**ABU GHRAIB DAIRY
ABU GHRAIB, IRAQ**

**SIGIR PA-09-172
JANUARY 14, 2010**

Summary of Report: PA-09-172

SUBJECT: Report on the Abu Ghraib Dairy, Abu Ghraib, Iraq
(SIGIR Report Number PA-09-172)

Figure 2. Primary truss configuration

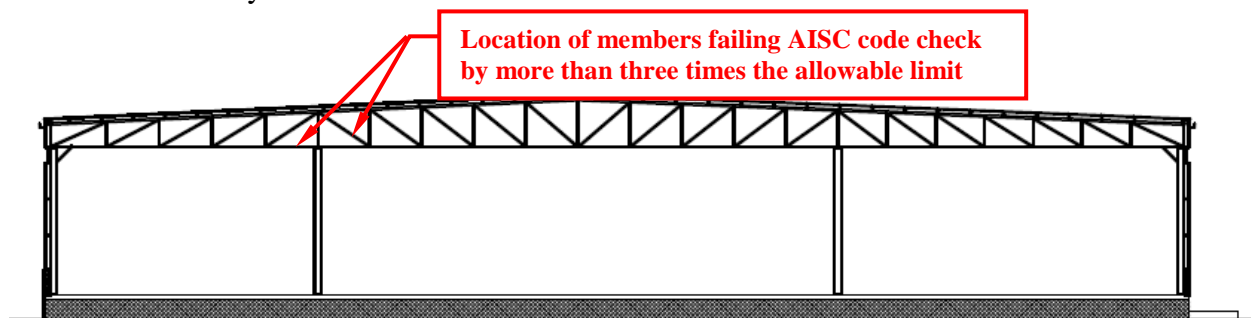
- Based on the contractor's calculations, five members of the truss were designated as failing the AISC code check. Two of the members failed the code check by more than three times the allowable limit (Figure 2). Failing by a factor of this magnitude indicates that the members could yield and possibly fracture under the design load.

The contractor's proposed structural design consists of steel columns and continuous truss construction with sandwich panel cladding¹⁸ for the roof and sidewalls. Roof loads are carried by the multi-span steel trusses, which have two configurations. The primary configuration has steel columns supporting the truss at the ends and at approximately one-third span (Figure 2). The columns are centered on a truss panel point (the location of intersecting truss members), which is appropriate. Based upon the contractor's drawings, it appears that the member sizes have been modified to accommodate the stress reversal¹⁹ over only one of the interior columns.

Figure 3. Truss configuration at mezzanine level

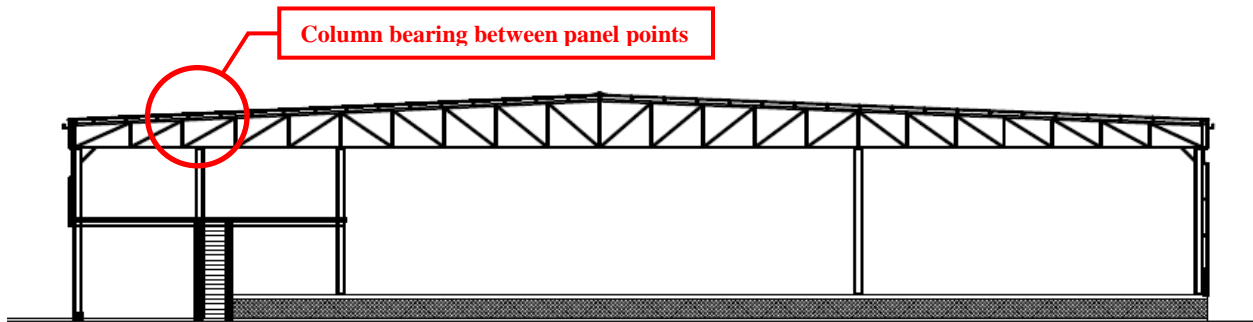
In the area of the mezzanine, the plans show additional columns (Figure 3), which extend through the mezzanine to the underside of the truss. The additional bearing locations provided by these columns are not at a truss panel point. The resulting reactions from these columns will introduce bending into the lower chord of the truss. SIGIR is

concerned that the members used in the lower chord of the truss are relatively light and do not appear to have the capacity to resist a significant amount of bending stress in addition to the compressive load that will result from the intermediate support.

Figure 4. Knee brace detail

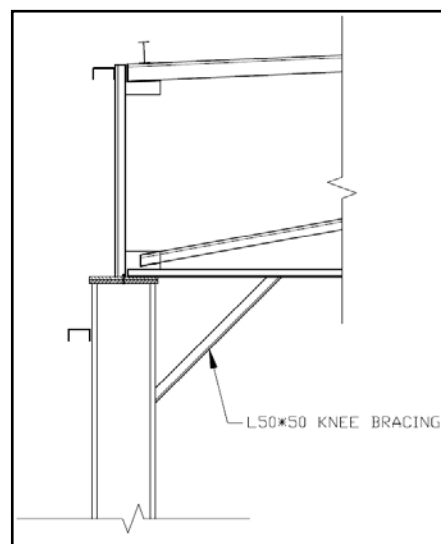
The contractor's design drawings do not address the method used to resist lateral loads parallel to the building's gable. It appears that the design incorporates diagonal cross bracing between several bays in the direction parallel to the ridge; however, there is no indication of bracing parallel to the gable (slope). In addition, the building's use of column and truss construction requires additional consideration of lateral loads. The only members that appear to be placed to provide lateral stability in the axis of the gable are the diagonal knee braces (Figure 4). These knees appear to be severely undersized, considering their location and configuration.

If the braces are used to resist lateral loads, the connection between the columns and truss would become, at least, partially fixed. This would introduce significant load into the lower chord of the truss, which appears to be already undersized. Fixing the truss/column connection would also introduce a lateral component into the column reaction; special consideration would then be required in the design of the foundation to resist this load.

Site Photo 1. Typical foundation pedestal and anchor bolts

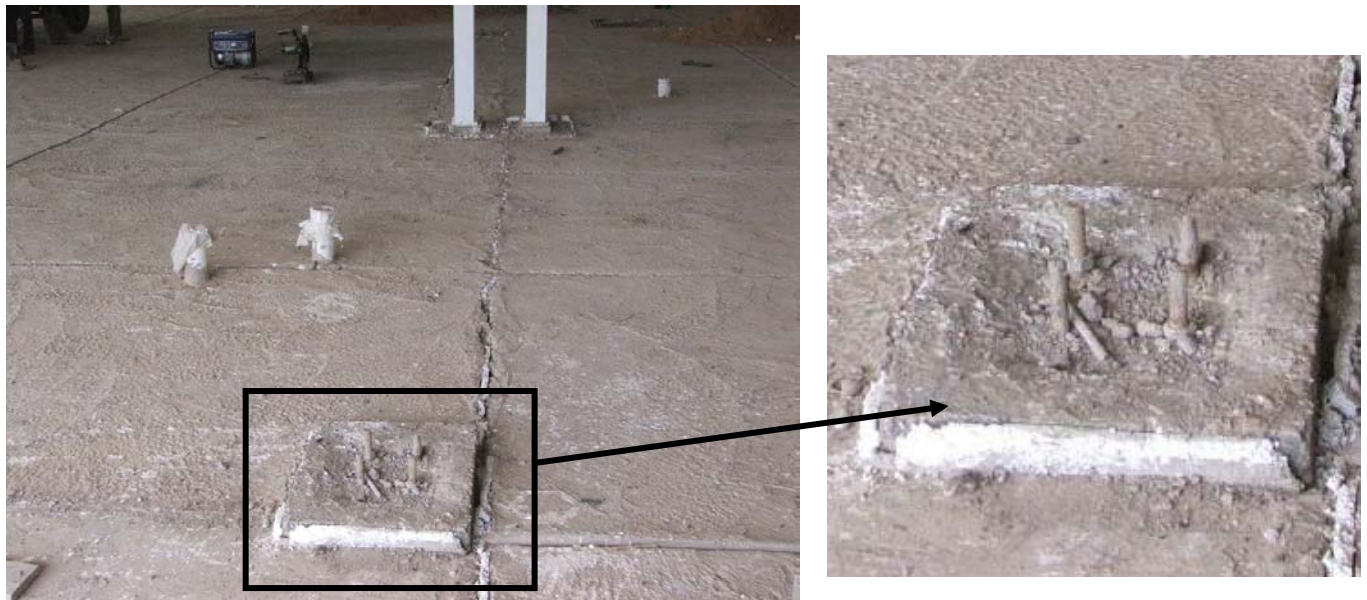
At the time of the site visit, the foundations for the facility were installed. The foundation system appeared to be concrete pedestals with steel anchor bolts attached to the base plates of the steel columns (Site Photo 1). The foundation system also included spread footings to support the concrete pedestals and columns. Since the foundation was in the later stages of construction, only the upper portion of the foundation was exposed for inspection; consequently, SIGIR could not verify the construction of the foundation.

Site Photo 4. Cross brace conflict with CMU perimeter wall

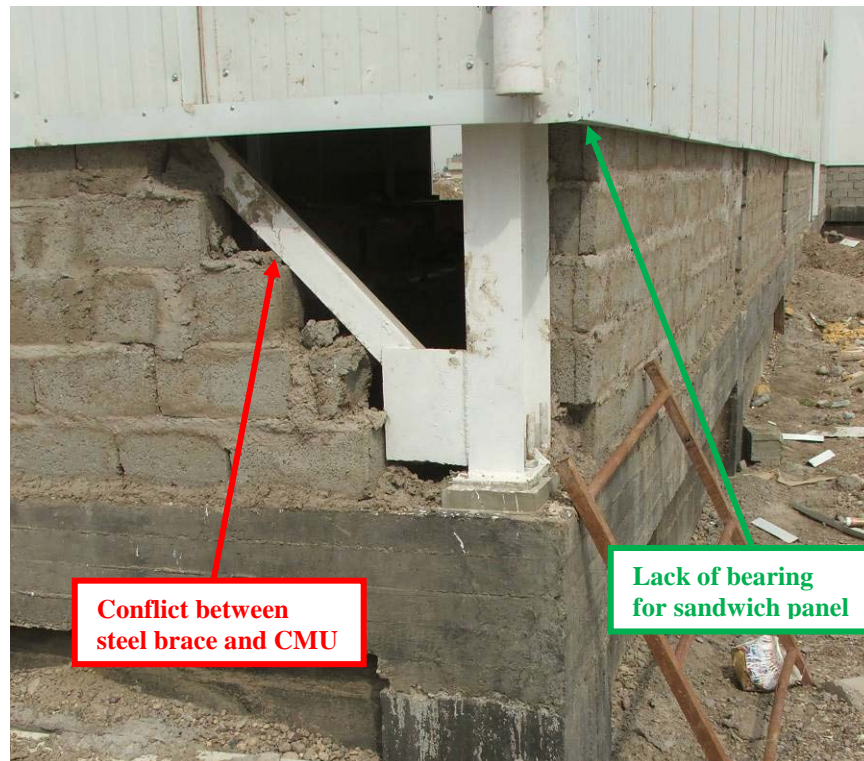
The CMU wall interferes with the steel cross bracing between several of the columns (Site Photo 4). It appears as if the contractor's solution to this issue was to lay the CMU wall around the bracing and coat the entire area with plaster. However, this approach may cause future problems as the steel bracing moves independently of the CMU wall causing recurrent cracking at the location.

Previously, SIGIR noted that due to the contractor's deviation from the design drawings, the steel cross bracing for the structure conflicted with the CMU perimeter wall. To correct this, the contractor removed the CMU wall, relocated the steel cross bracing to the interior of the wall, and reconstructed the wall (Site Photos 19 and 20).

Site Photo 5. Course of CMUs placed with cores horizontal

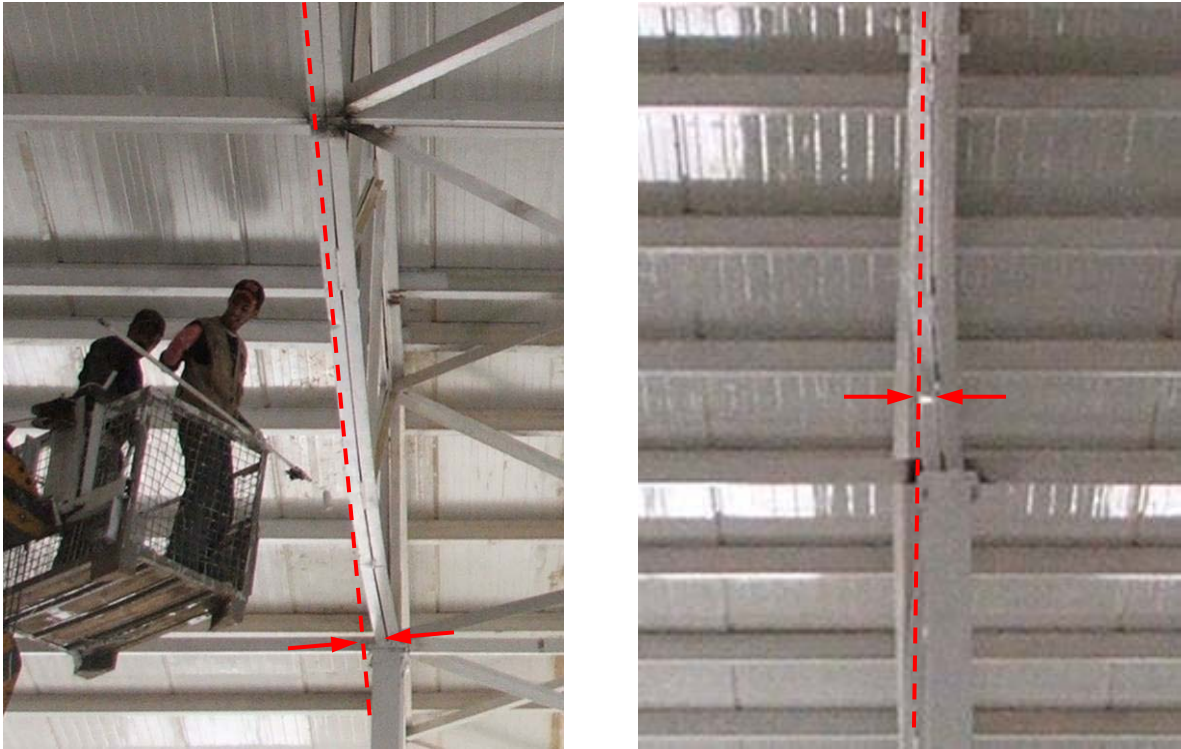
SIGIR also noticed several areas where one course of CMUs was laid on their sides (cores horizontal) (Site Photo 5). The detailed plans did not show this type of construction technique and it is unclear why the contractor did this. SIGIR's concern is that CMUs are significantly weaker when placed in this orientation. If these CMUs are intended to support the weight of the loaded floor slab, additional reinforcement of this area is needed.

The quality of the construction of the floor slab was very poor and appeared to have been poured without the correct tools or equipment. The slab has high and low spots in various places and raised tool marks from what appears to be preliminary leveling of the

slab. There is no indication that final finishing was performed after preliminary leveling. The slab's inconsistency may create problems for forklift traffic and future equipment installation.

Site Photo 18. Contractor's truss modification

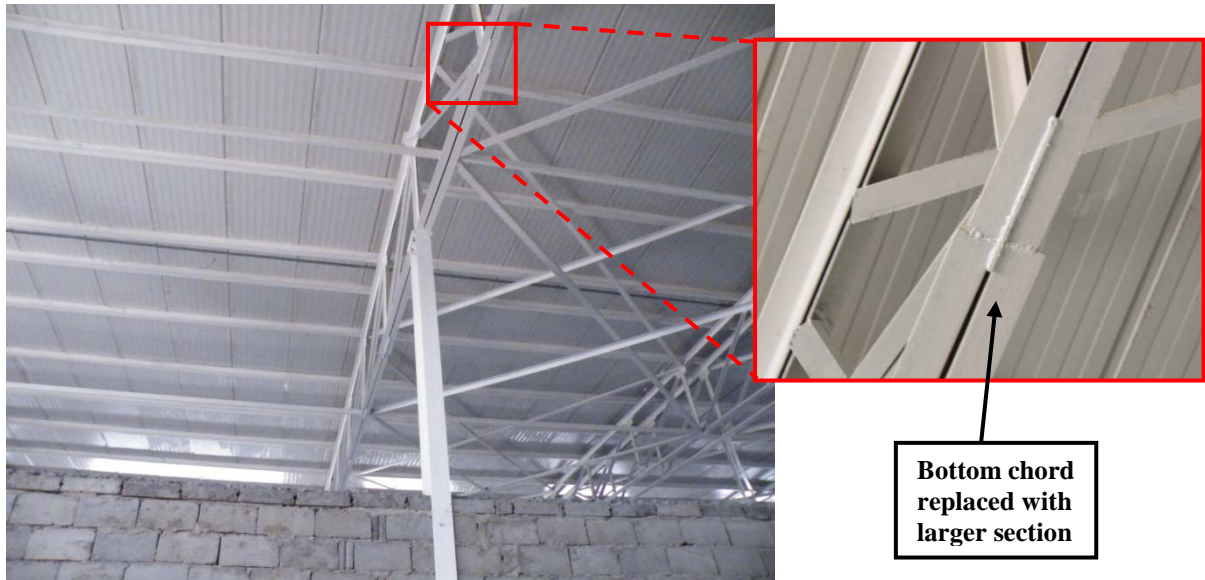
In order to remedy the deformation of the roof trusses SIGIR previously identified, the contractor's modification included the removal of the lower truss chord in the area where

it was inadequate and replaced it with a larger section. Aerial lift capabilities were not available at the time of the site visit; therefore, a hands-on inspection of the repair could not be made. However, SIGIR was able to verify that the trusses had a larger bottom chord section in the areas previously noted as deficient (Site Photo 18).
